Product Bulletin:

## Subject: Subframe Design Improvement for Drop Frames

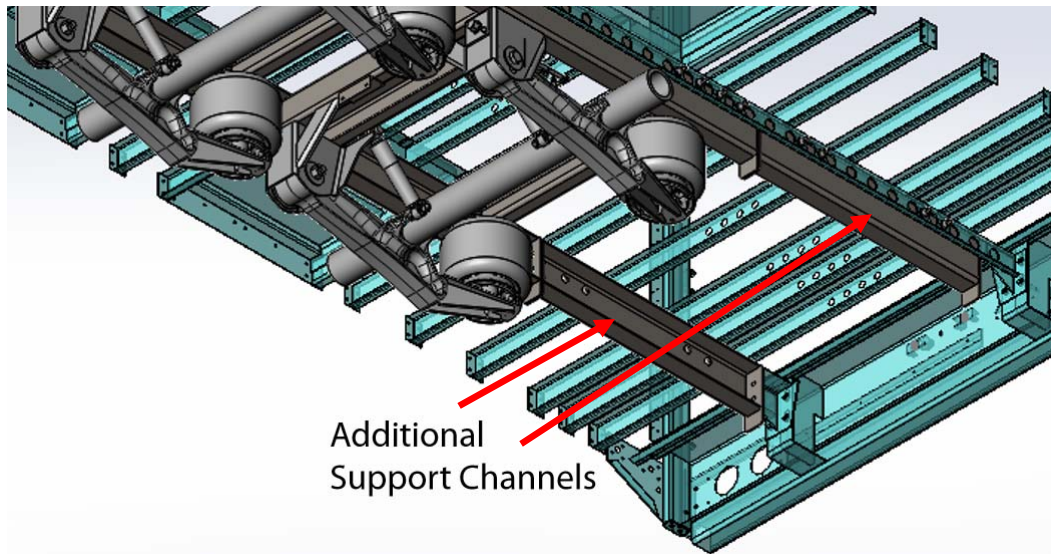
Stoughton Trailers has implemented an improvement to the design of the drop frame trailers. The suspension subframe channels have been extended to provide greater support to the floor at the rear of the trailer. The new 2-piece design provides additional strength in this critical area from the wear and tear of loading and unloading the trailer. The two pieces are connected with Huck fasteners to each other and to the slider rails. The channels now extend all the way to the rear frame, rather than spanning just the length of the fixed suspension.

Pictured below is the new design. This change is effective immediately.
